ST/SG/AC.10/C.4/2004/5
28 April 2004

**UPDATING OF THE GLOBALLY HARMONIZED SYSTEM OF CLASSIFICATION
AND LABELLING OF CHEMICALS (GHS)**

Classification of explosives

Transmitted by the European Chemical Industry Council (CEFIC)

Figure 2.1.1: Overall scheme of the procedure for classifying a substance, mixture or article in the class of explosives (Class 1 for transport)

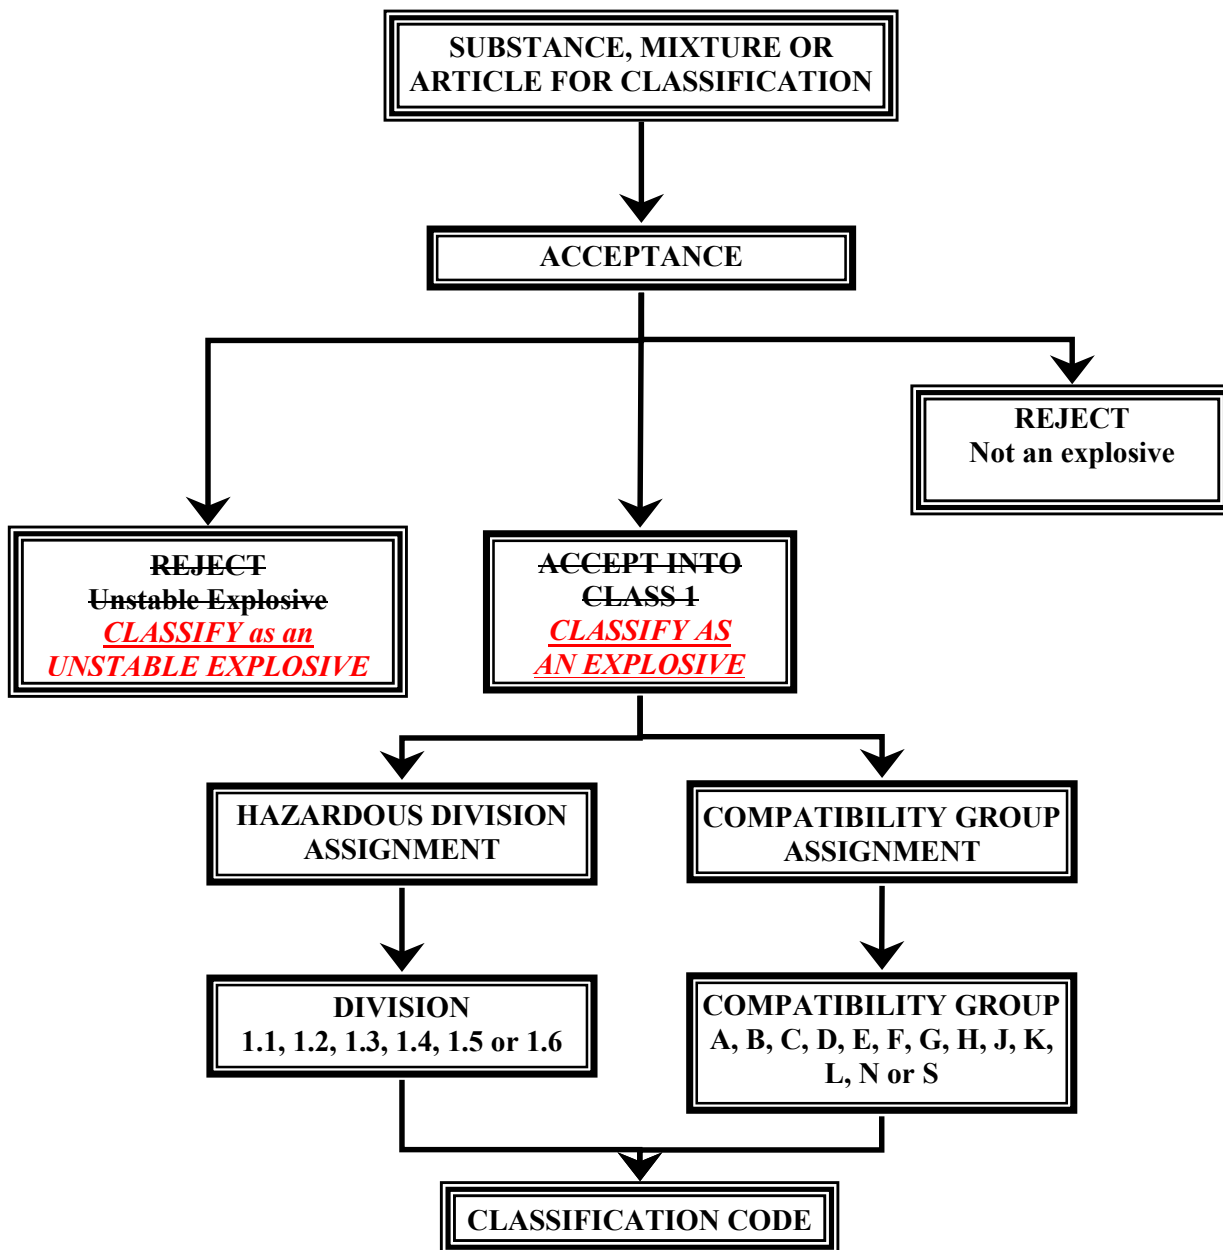
Figure 2.1 of the GHS is based on Figure 10.1 from the United Nations Manual of Tests and Criteria and rejects Unstable Explosives from the classification procedure. However Unstable Explosives may occur in the workplace and need to be classified so that they can be regulated for the workplace, whilst at the same time maintaining their differentiation from other explosives so that they can be precluded from transport.

CEFIC is proposing minor amendments to Chapter 2.1 of the GHS to rectify the problem, and at the same time make some minor editorial amendments to the Chapter to bring it in line with GHS, rather than transport, terminology. The proposal covers amendments to Chapter 2.1 except for Figure 2.1.3, and the guidance in 2.1.4.2.

Figure 2.1.2: Procedure for provisional acceptance of a substance, mixture or article in the class of explosives (Class 1 for transport)

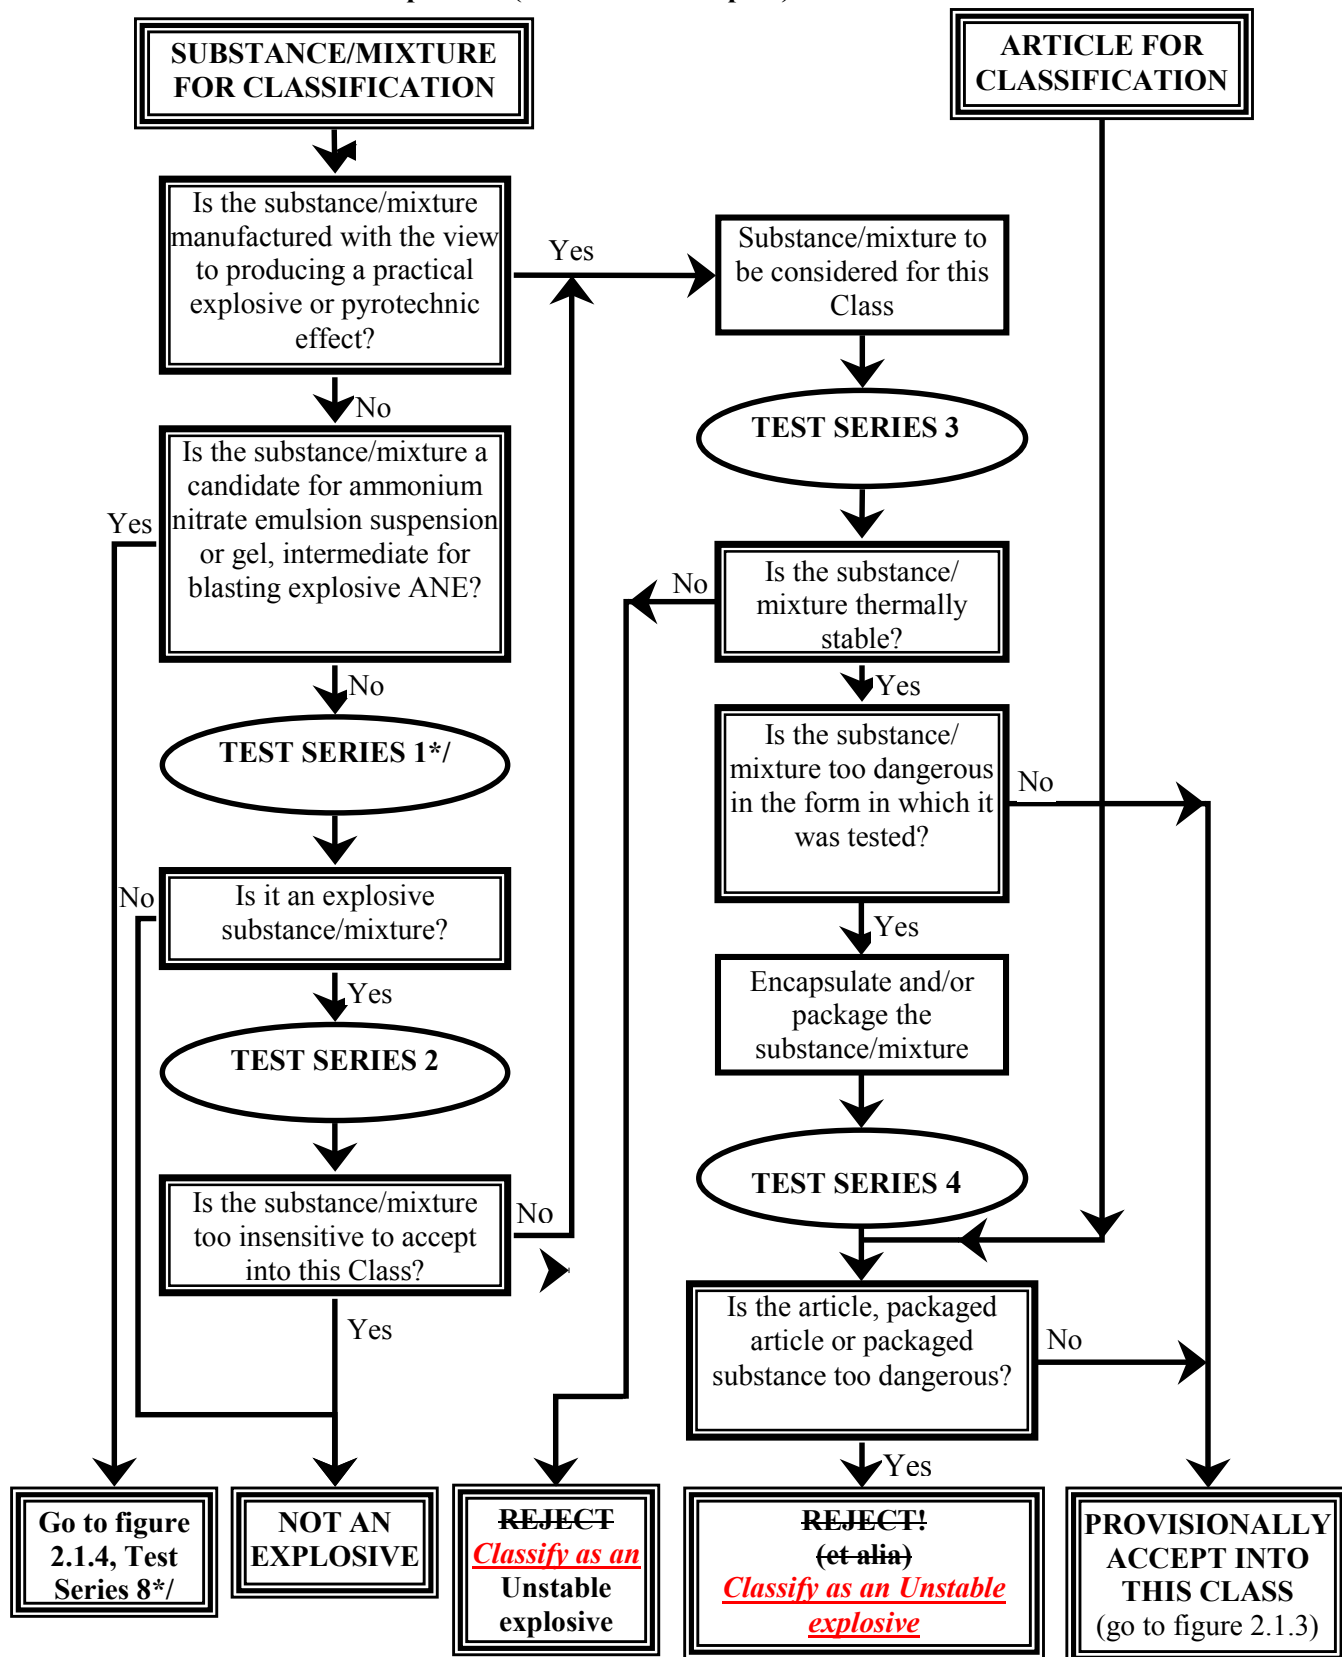
**/ For classification purposes, start with test series 2.*
